January 19, 2023

**RE: REQUEST FOR CLARIFICATION REGARDING NMED NOTICE OF DISAPPROVAL
FOR THE WORK PLAN FOR GROUNDWATER MONITORING
BULK FUELS FACILITY SPILL
SOLID WASTE MANAGEMENT UNIT ST-106/SS-111
KIRTLAND AIR FORCE BASE, NEW MEXICO
EPA ID# NM6213820974
HWB-KAFB-21-003**

Figure 1: Linear regression of for sample pairs with both results greater than the detection limit.

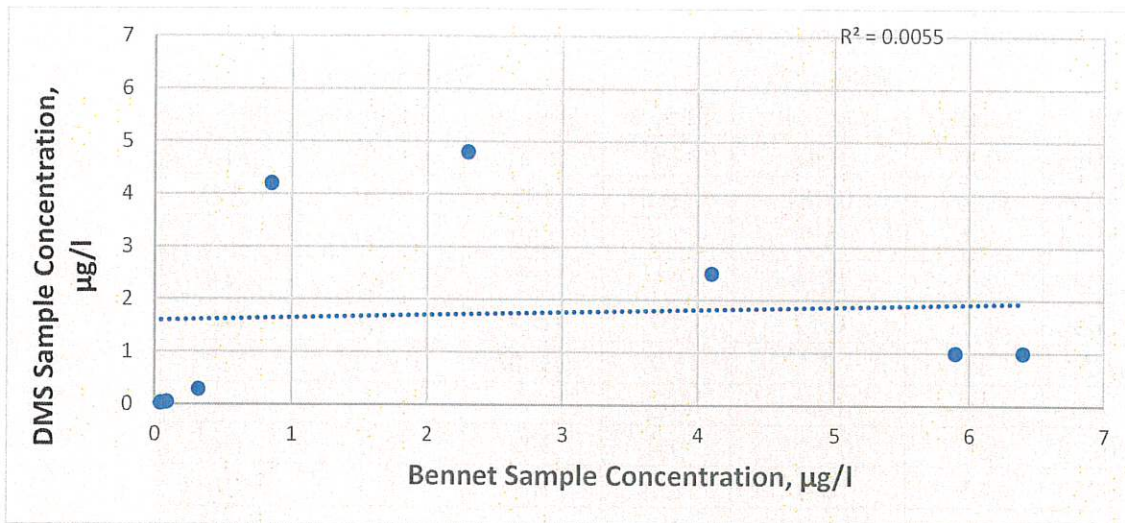
The Permittee then states, "the RPDs [relative percent differences] presented by NMED as an attachment to the 2022 NOD consider samples that were either non-detect (ND) or estimated concentrations for 1,2 Dibromoethane. The practice of using results at or below the detection limit is not consistent with NMED's explanation for how RPDs were calculated in the attachment. From 2022 NOD: *"RPDs were calculated for all concentration data with values greater than the detection limit"*." NMED re-evaluated the data without any ND or estimated concentrations and the results demonstrate a lack of correlation of the data: the linear regression resulted in an R^2 value of 0.0055, orders of magnitude below the acceptable correlation coefficient of 0.9. See Figure 1 below.

The Permittee appears to use selective guidance to imply that NMED's evaluation is biased by outlying data or variations in duplicate samples that often exceed 50% or more. As shown in Figure 1 above, outliers are not the issue with the failed correlation. NMED evaluated all the duplicate data provided with the 2016 and 2017 active vs passive evaluations; for the 10 duplicate EDB samples provided, the highest RPD was 26.6. Also, for the five duplicate benzene samples, the highest RPD was 11.1. See Table 1 below. Therefore, the data indicates that the cited guidance does not apply to the data collected at the site and that the significant differences in concentrations between active and passive sampling are not related to outliers or duplicate sample variations.
